Dewberry Response to USGS Review of the NRCS Maryland LiDAR Processing Project

Produced for U.S. Geological Survey

USGS Contract: G10PC00013

Report Date: 10/16/2012

Figure 2- Tile 18SVH284403. Bridges have been removed from ground (orange) and reclassified to class 1 (white)

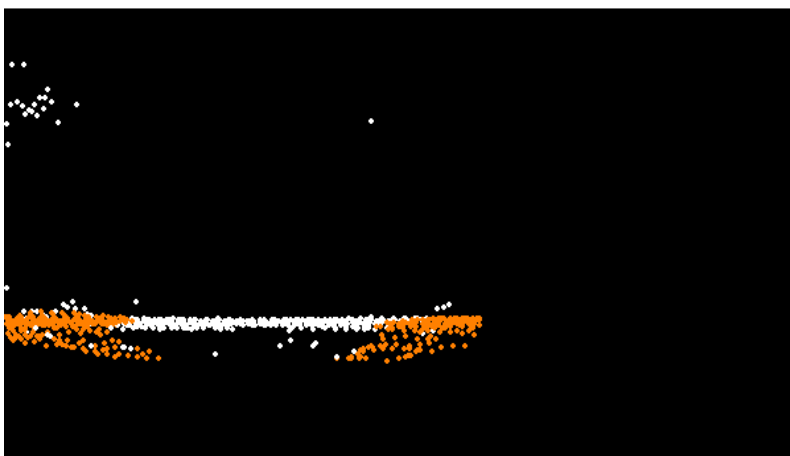
There were three locations where Dewberry interpreted a feature as a culvert and included it in the ground surface. USGS identified these features as bridges, not culverts. Dewberry has modified the points and removed these features from the ground surface.

Figure 4-Tile 18SVH494493. No additional points can be removed from ground classification. Bridge “saddles” are a visual artifact resulting from interpolation of a continuous surface.

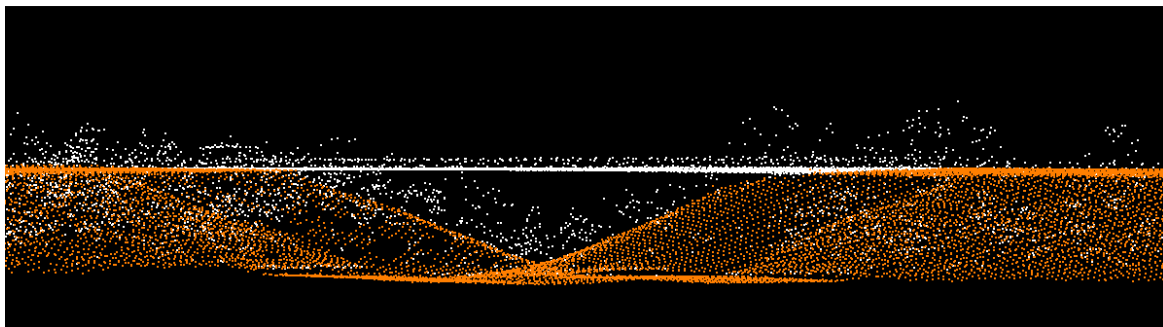
There were three locations where USGS made calls regarding visual artifacts. The DEM surface models are created from TINs or Terrains. TIN and Terrain models create continuous surfaces from the inputs. Because a continuous surface is being created, the TIN or Terrain will use interpolation to triangulate across a bridge opening from legitimate ground points on either side of the actual bridge. This can cause visual artifacts or “saddles.” These “artifacts” are only visual and do not exist in the LiDAR points or breaklines. No points were modified in these locations.

Figure 6-Tile 18SVH389238. Culverts have been reclassified from class 1 (white) to ground (orange).

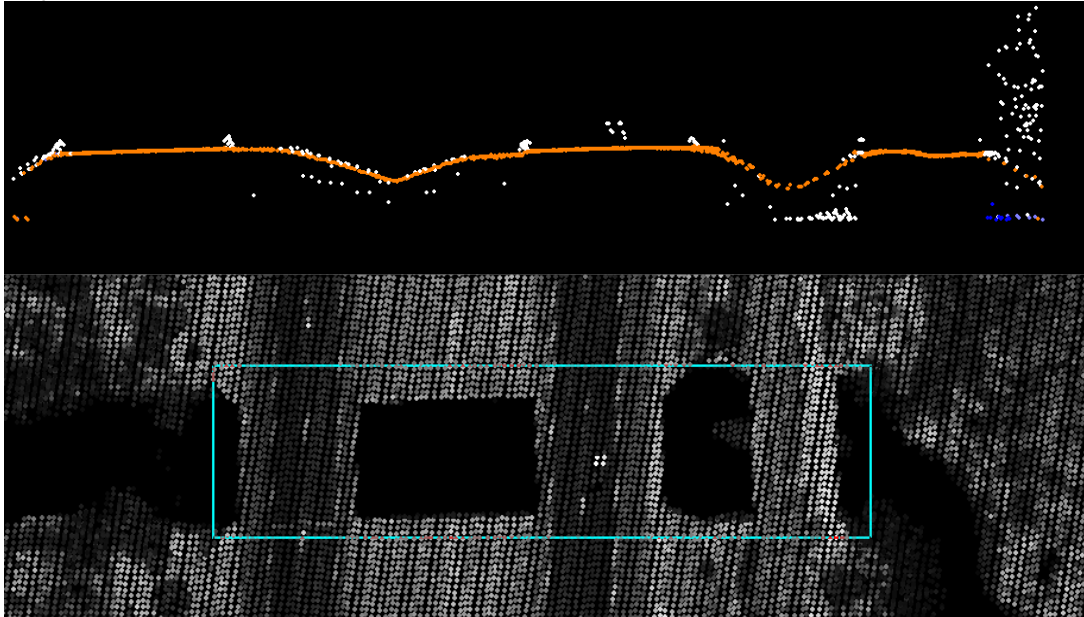
There were three locations where Dewberry interpreted a feature as a bridge and removed it from the ground surface. USGS identified these features as culverts, not bridges. Dewberry has modified the points and added these features to the ground surface. An example is shown below.

Figure 7-Tile 18SVH494553. All vegetation points have already been removed from ground (orange). No modification required as mounds are legitimately part of the ground surface.

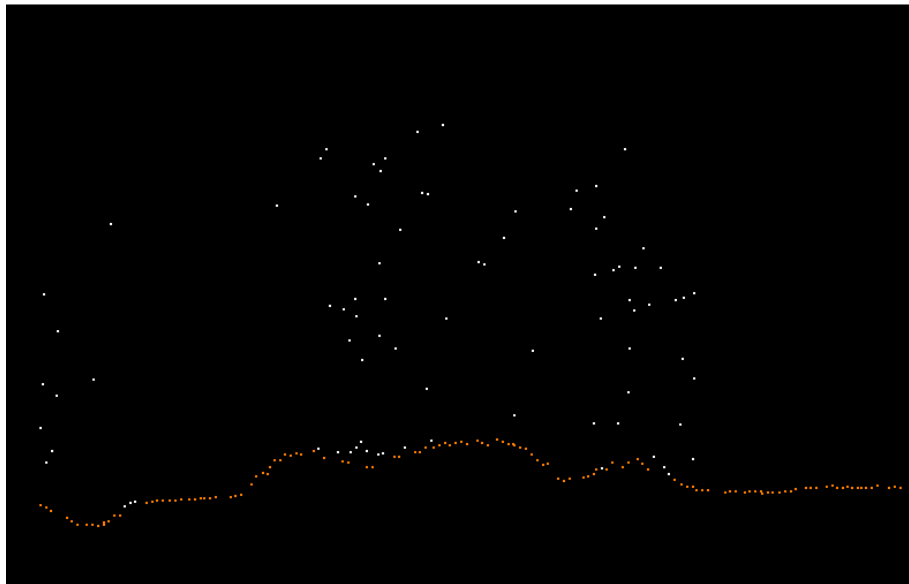
There were two calls to remove features from the ground surface. At first glance these areas may resemble vegetation. However, as the profile shows, the vegetation has been removed and the small mounds are correctly left in the ground. There was one call to add points to ground along a road bank. Points were modified and additional points were added to the ground surface. Examples are shown below.

Figure 11 – Tiles 18SVH359553 and 18SVH374553. An additional pond breakline has been collected for this feature and used to flatten the feature in the redelivered DEM. The LAS have been corrected to reflect the addition of this feature.

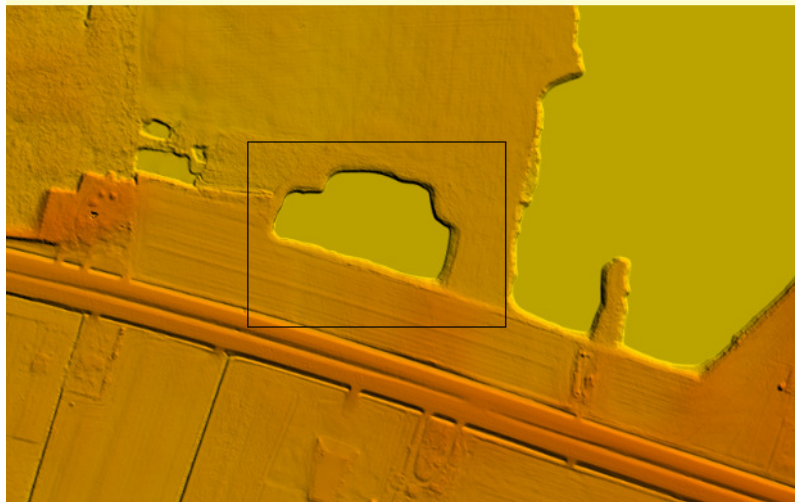
There were four locations where USGS identified areas of water that were not included in the collected breaklines. While the interpretation of the feature may be questionable in the intensity imagery, Dewberry agrees with all four calls after reviewing color imagery and the available LiDAR points. There is one location called out by USGS where the elevation of the breaklines was too low. After reviewing the LiDAR, Dewberry confirmed that the elevation was not accurate and modified the elevation of the breaklines up stream of the structure/ spillway.
